W3F1-2004-0073

**SUBJECT:** Supplement to Amendment Request NPF-38-249,  
Extended Power Uprate  
Waterford Steam Electric Station, Unit 3  
Docket No. 50-382  
License No. NPF-38

By letter (Reference 2), the Nuclear Regulatory Commission (NRC) staff requested additional information (RAI) related to reactor systems. By letters (Reference 3 and Reference 4) Entergy responded to 60 of the 61 questions and committed to provide the remaining response in a future supplement. Entergy's response to the last unanswered question is contained in Attachment 1 to this letter.

Figure 2.13.4.3.2-7  
CEA Ejection Core Power vs. Time for Peak RCS Pressure

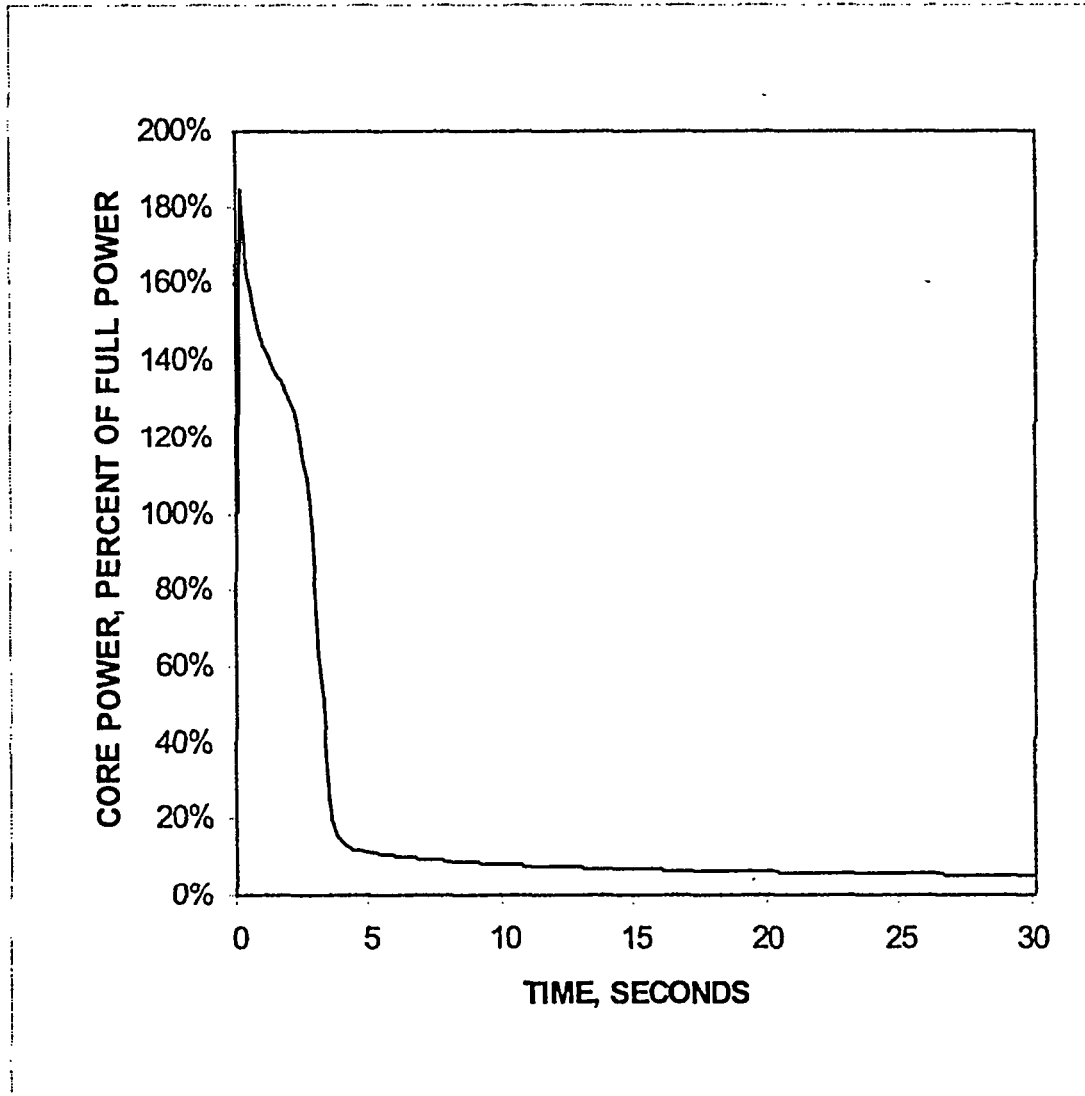
- PUR Tables 2.13.4.3.2-1, 2.13.4.3.2-2 and 2.13.4.3.2-3 are UNCHANGED.
- The information in PUR Table 2.13.4.3.2-4, the RCS Peak Pressure Sequence of Events, is replaced.
- PUR Table 2.13.4.3.2-5 is UNCHANGED.
- PUR Figures 2.13.4.3.2-1 through 2.13.4.3.2-6 are UNCHANGED.
- The core power vs. time response in PUR Figure 2.13.4.3.2-7 is replaced.
- The core heat flux vs. time response in PUR Figure 2.13.4.3.2-8 is replaced.
- The core coolant temperatures vs. time response in PUR Figure 2.13.4.3.2-9 is replaced.
- The RCS pressure vs. time response in PUR Figure 2.13.4.3.2-10 is replaced.
- The SG pressure vs. time response in PUR Figure 2.13.4.3.2-11 is replaced.
- The reactivity components vs. time response in PUR Figure 2.13.4.3.2-12 is replaced.

presented in Section 2.13.4.3.2 of the PUR included the results of a peak reactor coolant system (RCS) pressure case. The peak pressure case has been reanalyzed to conservatively prevent actuation of the pressurizer sprays and to model the occurrence of a turbine trip following reactor trip. The revised analysis indicates that peak calculated RCS pressure increased from 2519 psia previously reported in Reference 1 to 2613 psia, a value less than the acceptance criterion of 2750 psia (i.e., 110% of RCS design pressure). Revised PUR pages are provided in Attachment 2 and supersede the corresponding pages previously provided in Reference 1.
